IC Corporation

SAFETY RECALL

SAFETY RECALL 05509

An incorrectly manufactured burner tube in the Webasto heater installed in the bus can fail prematurely.

Figure 1.

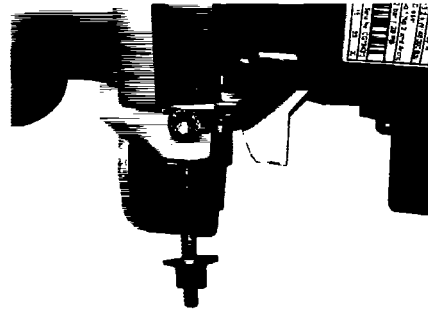
4. Removing the heater from the vehicle is normally not necessary. For opening of heaters, both eyebolts of the housing are to be loosened (see figures 1 & 2).

7. When reassembling the burner head to the heat exchanger the eyebolts and ears must be in the correct position during tightening (see figure 1). **Tighten the eyebolts to a maximum of 4.0 Nm (35.5 lb/in.). Over-tightening could damage the casting. If the split pin was removed it must now be refitted.**
8. Once the burner head has been re-installed, make sure that all four grommets (2 right and 2 left) are in place. To minimize combustion air leakage, ensure grommets are fitted tightly around wire cables and fuel pipes. (see figure 5).
9. In the case of the Scholastic Series heater with a **single line fuel system**, make sure the blank fuel pipe slot in the casting has a **solid (no hole) grommet** in place.

Figure 3.

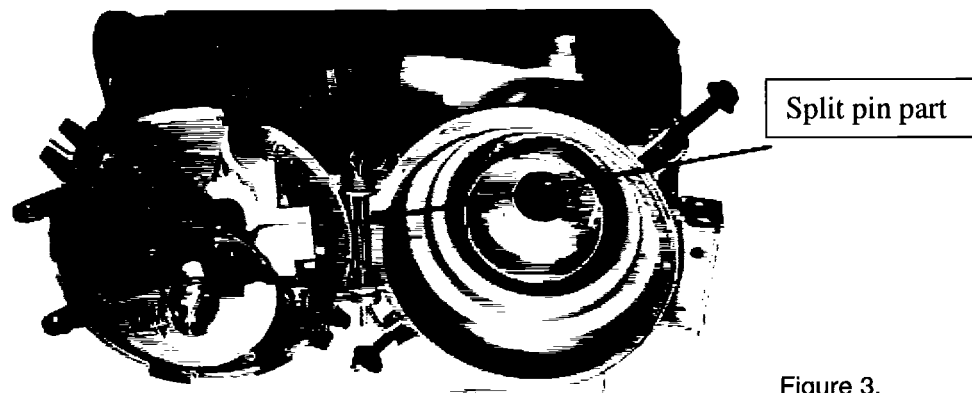
5. Once the burner head has been unlatched, swing it open to the side (see figure 3). If there is no clearance to do so, or there is a risk of damaging the wiring harness or fuel lines, the split pin can be either removed or inserted in the other side of the housing **before** loosening the eyebolts. If there is not sufficient clearance, the burner head can be disconnected and completely removed. **CAUTION - do not damage the ignition electrodes (1) during the work. DO NOT change the screw position of the air intake bellows. This only happens if the adjusting screw is not properly tightened.**

Figure 6.

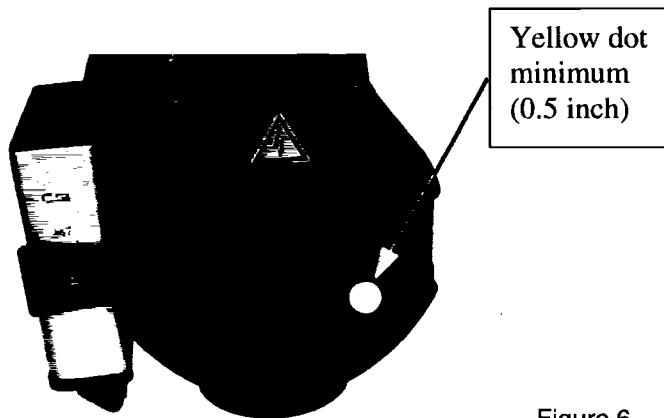
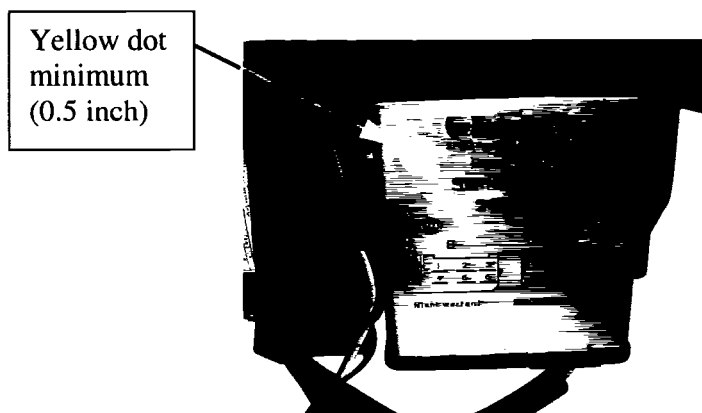
10. Place a water insoluble (permanent ink or paint) yellow dot, minimum $\text{Ø}10\text{mm}$ (0.5 in.), on the control unit and on the front side of the burner head (see figures 6 & 7) to identify corrected heaters.

1. **Before** starting work, check to see if the heater is already marked. This means the burner tube has been replaced already. Corrected heaters are marked with a yellow dot on the control unit or on the front side of the burner head cover (black plastic) or in both places (see figures 6 & 7).
2. Remove the heater power cable from the vehicle battery or disconnect the heater from other electrical source. Removing the heater from the vehicle is not generally necessary.
3. Inspect the heater for the following serial numbers. Only these serial numbers must have the burner tubes changed. **If the Webasto heater serial number is not on this list, DO NOT change the burner tube.**
